RE: S75W MODIFICATION APPLICATION – MIXED USE DEVELOPMENT UPON LAND AT 10 GRAND PARADE, CASUARINA (MP06\_0258-MOD-15)

We write with respect to the Department of Planning, Housing and Infrastructure (DPHI) request for additional information dated 15 July 2024. We respond to the matters raised as follows:

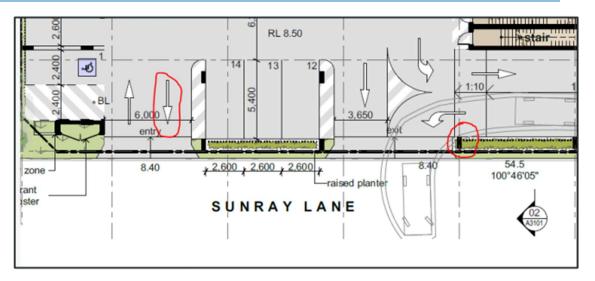
An assessment of the proposal against the parking requirements of Council's DCP is required

TTM have prepared a response to the above matters demonstrating, that Sunray Lane is capable of absorbing the additional traffic generated by the proposed development; a breakdown of parking requirements specified in Section A2 Site Access and Parking Code of the Tweed DCP 2008 and updated plans including swept paths.

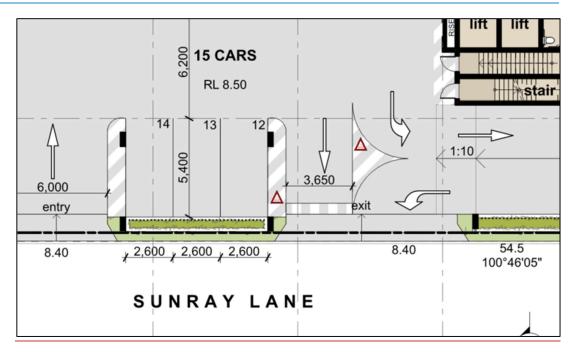
Manoeuvrability of vehicles travelling in, out and within the parking area is unclear. Swept path diagrams are to be provided with the following at a minimum:

- Detail of Sunray Lane in full including the verge and any significant details of the dwellings to the south that may impact on the manoeuvrability of vehicles.
- All possible vehicle movements when entering and exiting from Sunray Lane e.g. left- and righthand turns from Sunray Lane into the site.
- Access into and out of accessible parking spaces Nos 1 and 11 and other spaces at corners and junctions.
- Inconsistencies corrected as per below image marked up in red.

Note: All swept paths, including clearances, shall be free of obstruction and not result in any conflict with oncoming traffic.

Sunray Lane has an overall width of 7m by DP 1264557, and a road width of 5.7m as per the As-Constructed Survey submitted as part of this second RFI response. It is noted the kerbs to Sunray Lane are flush with the road and adjoining ground and measure approximately 150mm in width each, providing an additional 300mm and thereby increasing the trafficable width of Sunray Lane to 6m. Swept paths have been included in TTM's updated response showing two-way vehicle movements along the laneway.

Conflict management between vehicles turning right out of the basement and left out of the ground floor car parking area are proposed to be managed by incorporating a 'Give Way' sign and ground linework to those exiting the ground floor parking area, giving priority and right of way to those vehicles exiting the basement. Refer to image below.

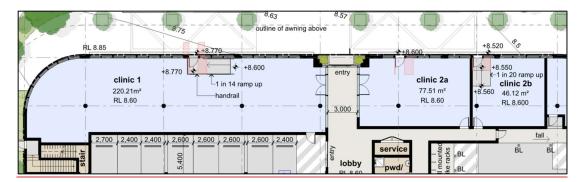
The submission received from Council and two public submissions queried whether the proposal could meet the street front activation requirements of MP06\_0258-Mod-10. Primarily, the concerns referenced the number of direct pedestrian access points from Grand Parade to ground floor tenancies, and a loss of retail/commercial mixed use.

Incorporation of direct pedestrian access to each ground floor tenancy would be required to be provided in accordance with Australian Standard AS1428. Compliance with AS1428 for this site would require the incorporation of a network of ramps to be located within the frontage of proposed clinics 1, 2a and 2b (Refer to Attachment 5 Street Access Plan). The incorporation of numerous ramps would result in the creation of additional trip hazards along the street frontage and within the entrance of the tenancies, weatherproofing issues, wayfinding problems and an aesthetically-challenged façade. As the clientele for the specialist medical suites are anticipated to be of an ageing demographic, providing access to tenancies that is safe and easy to navigate is of paramount importance.

Detailed design changes have resulted in the inclusion of ramps to ground floor Clinics 1 and 2b. Incorporation of these ramps provides direct street access whilst complying with AS1428. Street access has also been provided to clinic 2a however this is via a step up from the footpath into the tenancy. Equitable access to this clinic will continue to be achieved via the main lobby. Please see below and refer to Amended Plans dated 18/09/2024.
